REMEDIATION SYSTEM EVALUATION

FORMER HONEYWELL FACILITY
FORT WASHINGTON, PENNSYLVANIA

Report of the Remediation System Evaluation,
Site Visit Conducted at the Former Honeywell Facility, Fort Washington, Pennsylvania
January 30, 2003

FIGURE 4-2. POTENTIOMETRIC SURFACE MAP DEPICTING PUMPING CONDITIONS (1993).

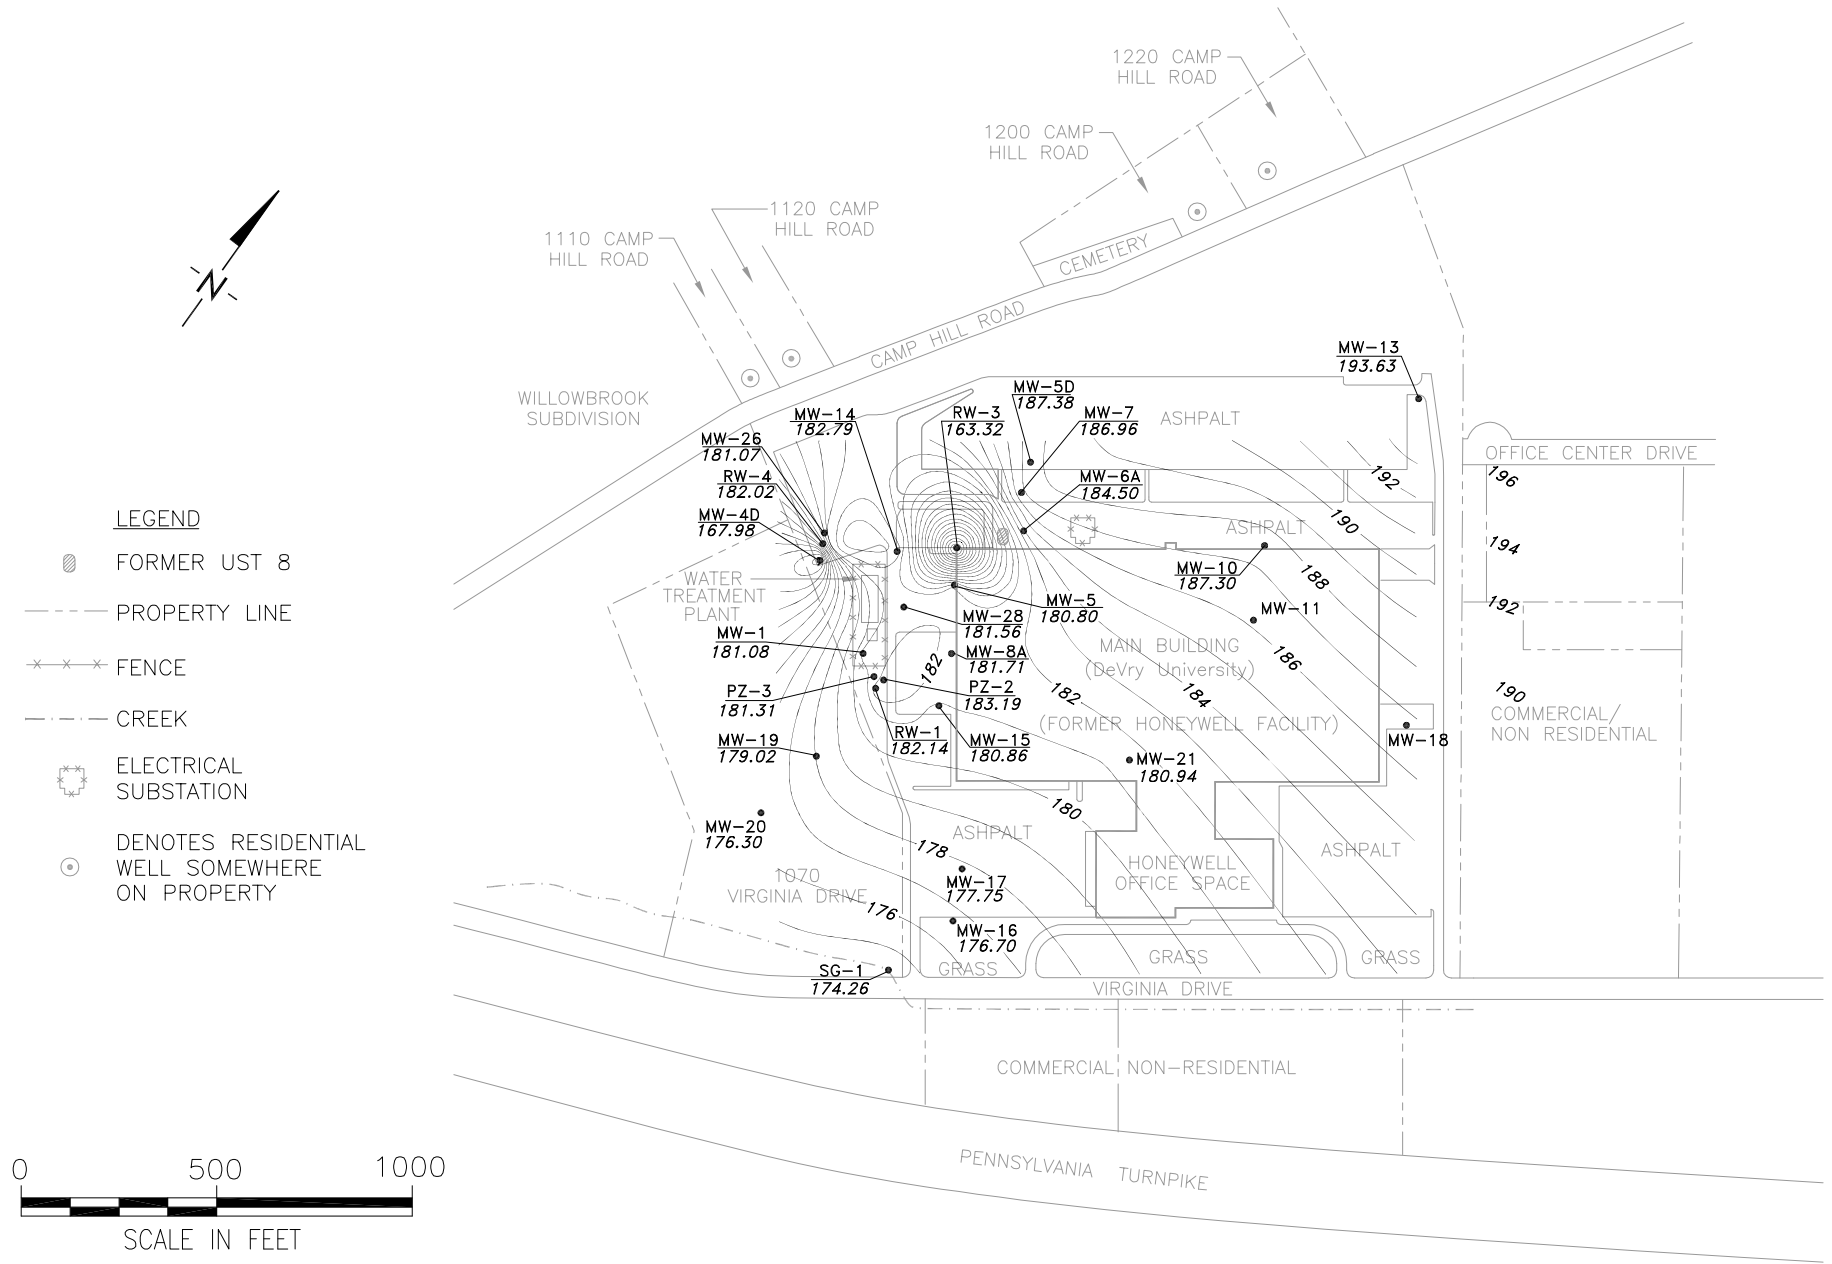
Potentiometric surface maps show an influence due to pumping, but as stated in Section 4.2.1, their development includes the use of water levels from operating pumping wells. As a result, the degree of drawdown and capture might be overestimated when using these potentiometric surface maps. Furthermore, as the *Draft Five-Year Review* indicates, the presence of complex geology with dipping beds and fracture orientations in three directions complicates analyses of ground water flow directions, particularly in Zone B.

Water levels should continue to be collected from all wells during sampling events, and potentiometric surface maps should continue to be developed. However, as stated in Section 4.2.1, the water levels from the operating wells should not be used when developing the potentiometric surfaces. Ideally, piezometers would be located near the extraction wells to provide a representative water level for the aquifer in those areas. Alternatively, the water levels from the extraction wells could be used if they are adjusted for well losses and the interpretation accounts for the likelihood that the drawdown is likely focused near the well (i.e., linear interpolation between the water level at the extraction well and other monitoring points is not necessarily a reasonable assumption). For this site, it is the opinion of the RSE team, that using corrected water levels from extraction wells is appropriate.
